LAND AT PALK ROAD, HAVANT

ADDENDUM TRANSPORT ASSESSMENT

<i>Document No:</i>	043.0035/ATA/2	
<i>Status:</i>	Original	
	<i>Name</i>	<i>Date</i>
<i>Prepared by:</i>	Jessica Miller	September 2023
<i>Checked by:</i>	Tom Fisher	September 2023
<i>Approved by:</i>	Mark Smith	September 2023

<i>Rev.</i>	<i>Date</i>	<i>By</i>	<i>Summary of Changes</i>	<i>Aprvd</i>
2	06.10.23	CID	Clients Comments	JM

Appendix I

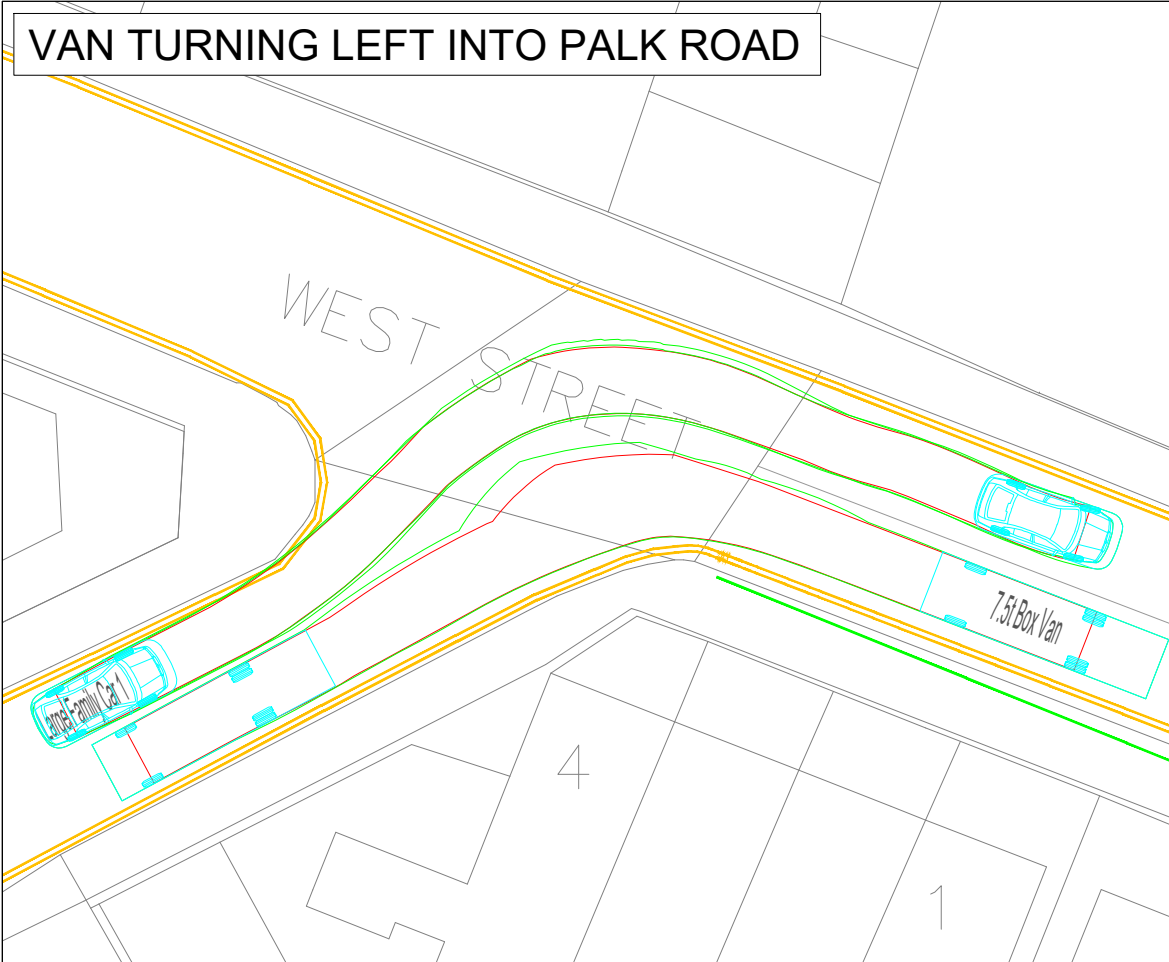
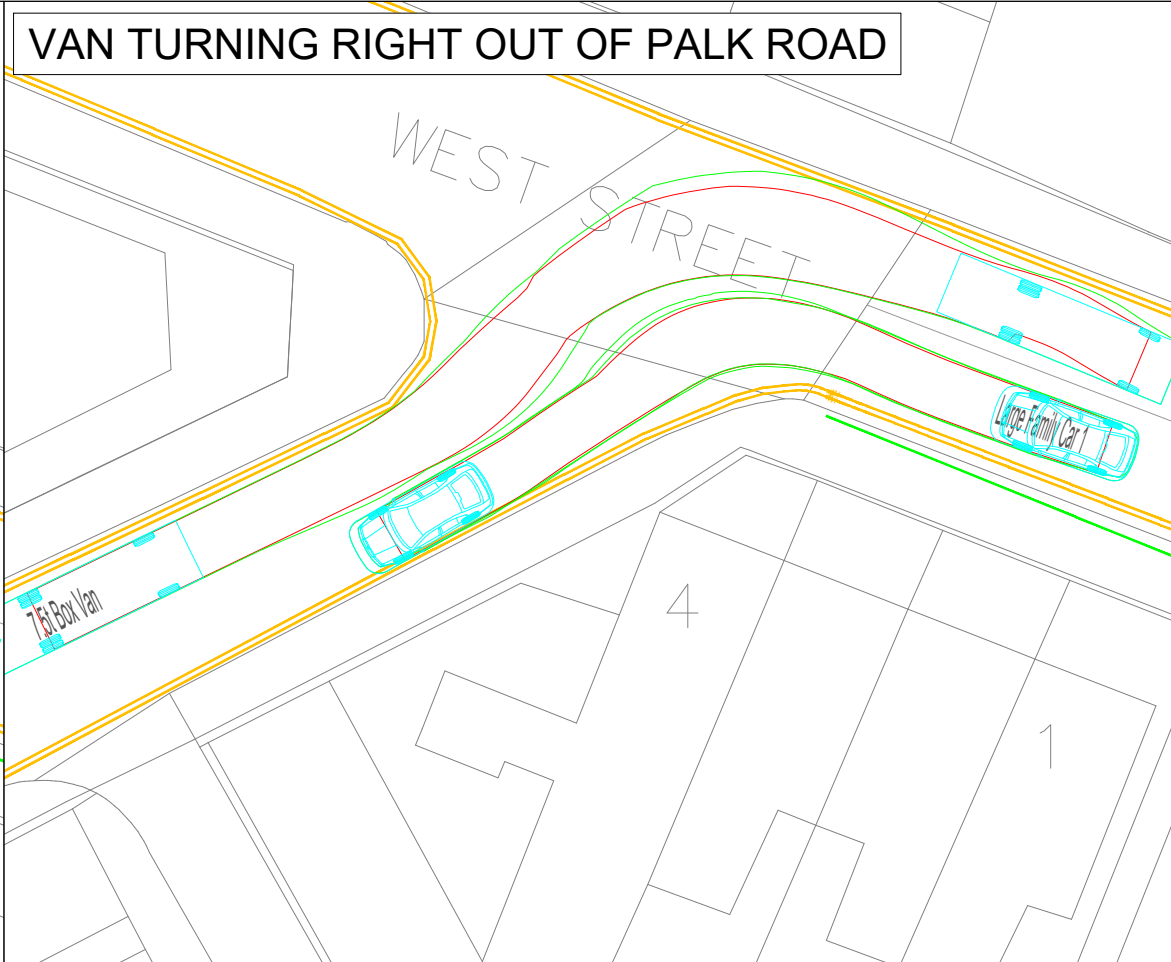
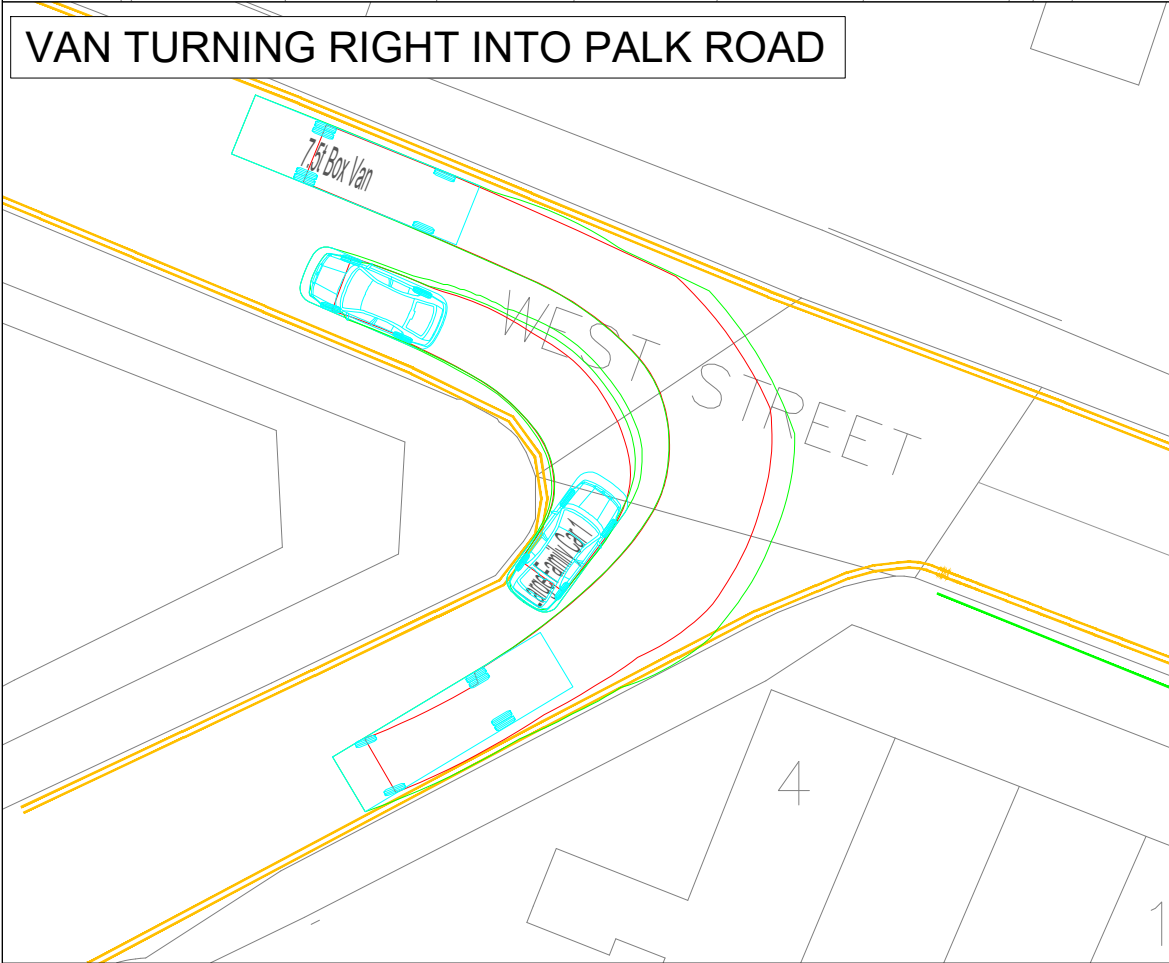
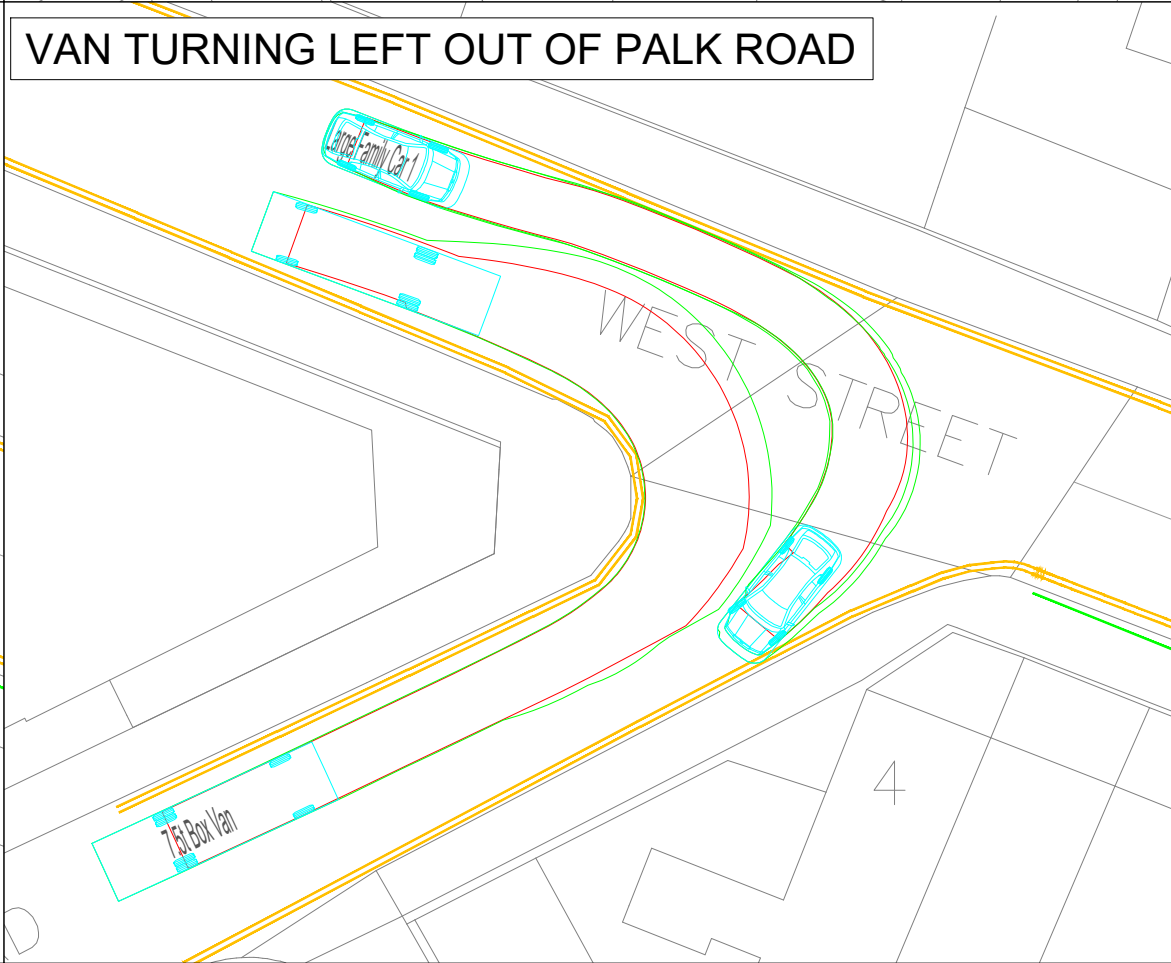
junction and the operation of the junction considering the intensification of use with the addition of development traffic. Tracking should be provided at the Palk Road/West Street junction for a delivery vehicle and car to ensure that this regular movement can be operated in a safe and suitable manner.

4.6 HCC also raised concerns with the geometry of the Palk Road/West junction and the operation of the junction considering the intensification of use with the addition of development traffic. Tracking was requested at the junction to show a delivery vehicle and car passing in a safe and suitable manner. Whilst this concern is noted and the tracking exercise completed and attached as **Appendix I**, it is worth re-iterating that the proposed development is a brownfield development and had been in operation as B8 storage for over 100 years for various land uses/owners. A commercial land use still remains on the site immediately adjacent to the east of the proposed development. Therefore, the junction has been operating satisfactorily for many years with much larger vehicles likely to have utilised the Palk Road/West Street junction without any recorded Personal Injury Accident (PIA) incidents. Therefore, the change of use from commercial to residential would reduce the number of larger vehicles using this access and thus provide a betterment than the previous situation. The tracking shown in **Appendix I** shows that a car and delivery vehicle can operate suitably and safely at the access.
